FLYING HORSE NORTH FILING NO. 1  
COUNTY OF EL PASO, STATE OF COLORADO  
CONSRTUCTION DRAWINGS  
DECEMBER 2017

FLYING HORSE NORTH FILING NO. 1  
STREET IMPROVEMENT PLAN  
STAGECOACH ROAD  
STA. 15+00.00 - STA. 30+00.00

FLYING HORSE NORTH FILING NO. 1  
DRAINAGE IMPROVEMENT PLANS  
DETENTION FACILITY NO. 1  
POND PLAN

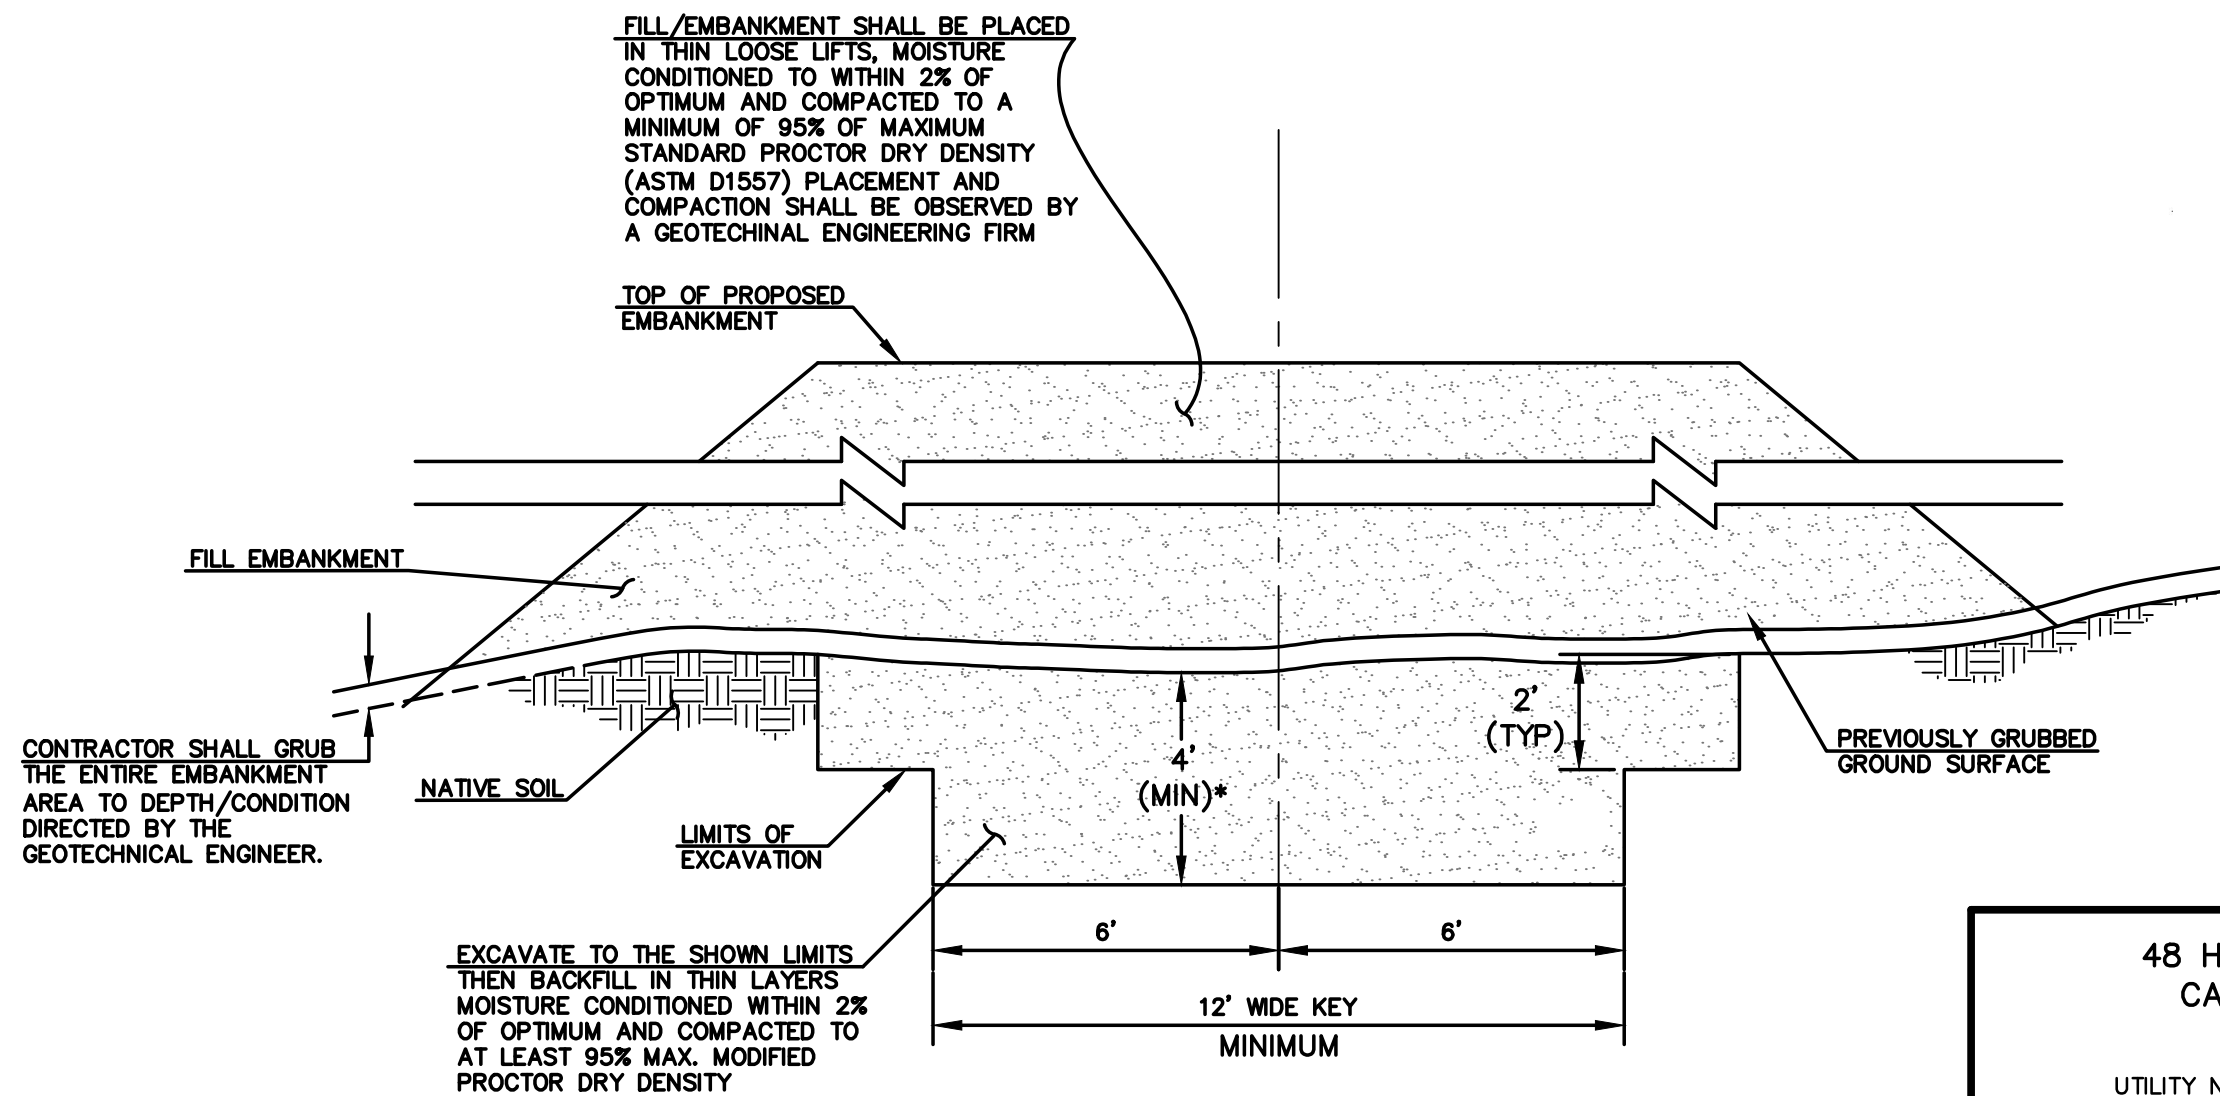
Identify the gravel type  
and depth for all pond  
details.
